Subject: LIFTGATE HARD TO LATCH IN COLD TEMPERATURES BELOW FREEZING	Bulletin No: 09-044/16
	Last Issued: 07/14/2016

This bulletin supersedes the previously issued bulletin(s) listed below. The changes are noted below in Red beside the change bars.

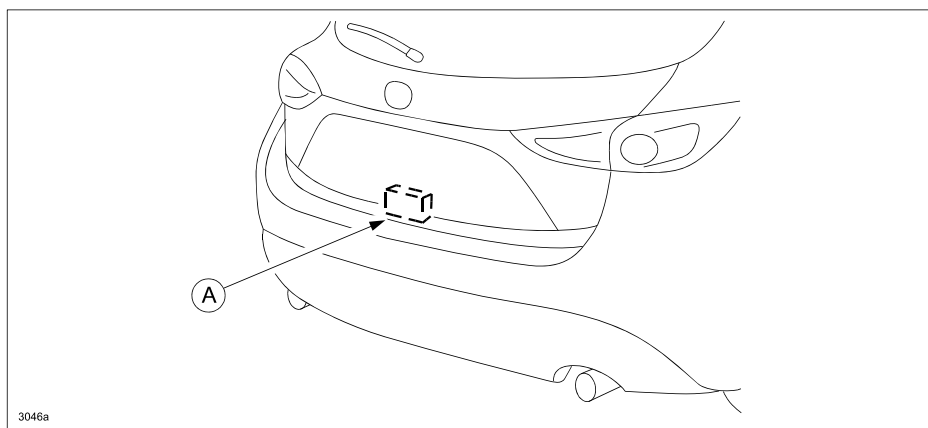
Some vehicles may exhibit a condition in extremely cold temperatures (below freezing) where the hatchback will not latch (half latch) when closing. This is caused by the stopper rubber, a component of the liftgate latch and lock actuator (A), hardening when the temperature drops below freezing. The stopper rubber has now been improved to eliminate this concern.

1. Verify customer concern.
2. Replace the liftgate latch and lock actuator with a modified one. Refer to MS3 online instructions or Workshop Manual section 09-14.
 - For Mazda3: LIFTGATE LATCH AND LOCK ACTUATOR REMOVAL/INSTALLATION.
 - For CX-5: LIFTGATE LATCH AND LOCK ACTUATOR REMOVAL/INSTALLATION.
3. Verify repair.
